**HENDY WIND FARM: Land Off A44 SW Of Llandegley Llandrindod Wells Powys**

**Application for discharge of condition 26 from P/2014/0672 (APP/T6850/A/17/3176128): Public Rights of Way**

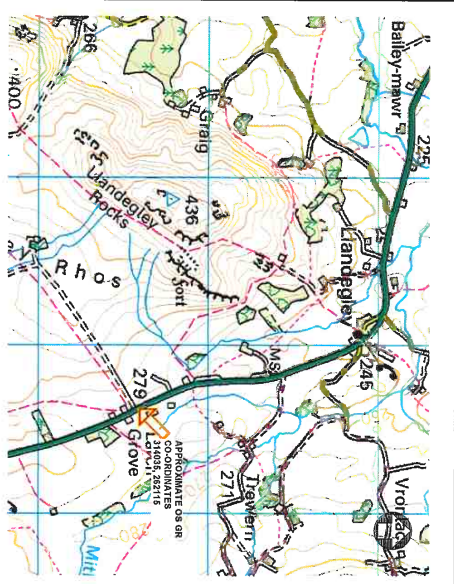
**Accidental damage:** Paragraphs 3.7 to 3.11 make little sense to those who have attended the site. Re damage to verges: compare and contrast photos below: HRP photo – unknown date but prior to commencement of development & resident's photo – 8<sup>th</sup> January 2019.

A11075\_701

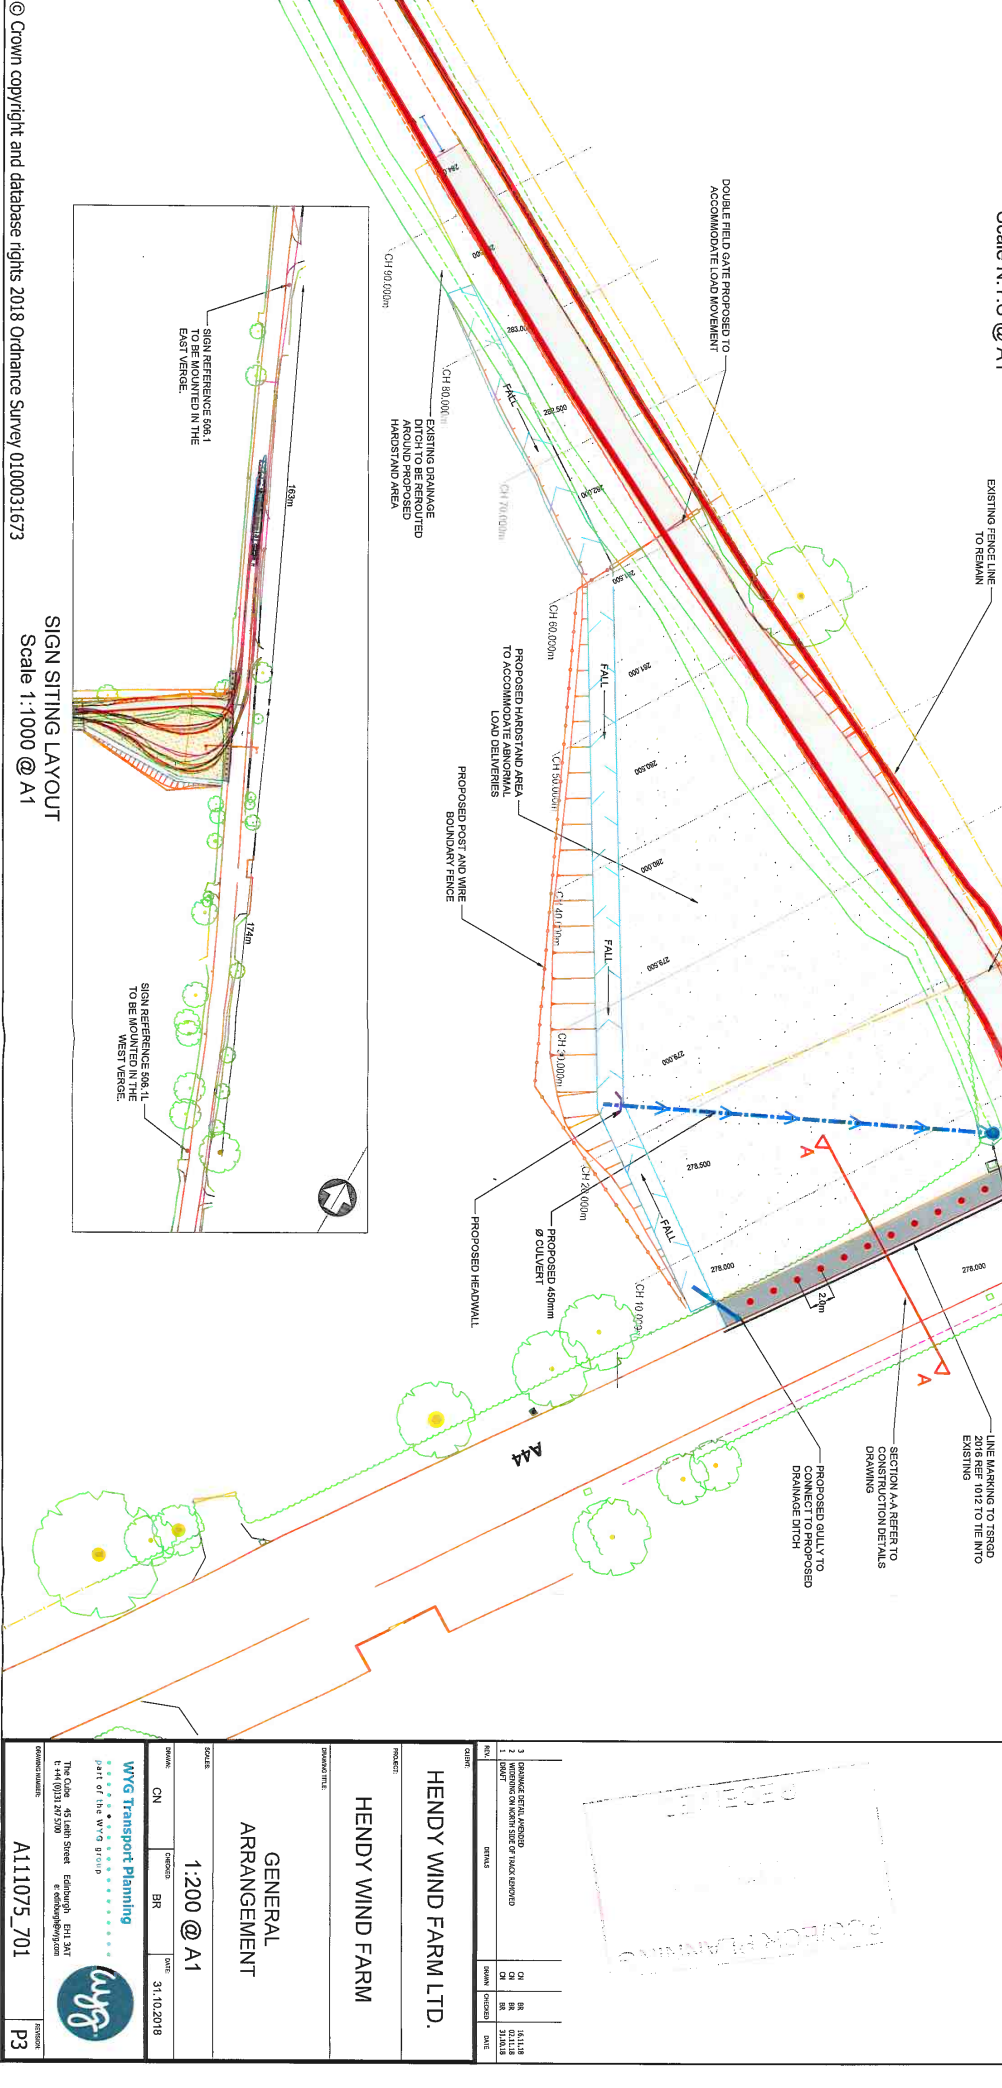
But since the developer plans substantial hard-surfacing works on the common which are intended to extend some 30m from the gate southwards down the A44, any promise to protect the verge is nonsensical. See extract from Highway Plans 119978 below.

**'4. Proposed Works/Damage Protocol':** Refers to the '*design of the planned road works*' without setting out what these are. We assume they are the works which are detailed in the Highway Plans 119978. This being so reversion to current state is not a possibility: the developer intends to drain and level a wet and undulating piece of land, put it down to hard surface and to remove all trees (shown in photos above) at the roadside. The area proposed for hardstanding is approximately 30m north/south and extends approximately 60m along the graziers' track. This work is neither reversible nor temporary and the HRP fails to address this fact. This work also requires new Planning Permission and Common Land permissions.
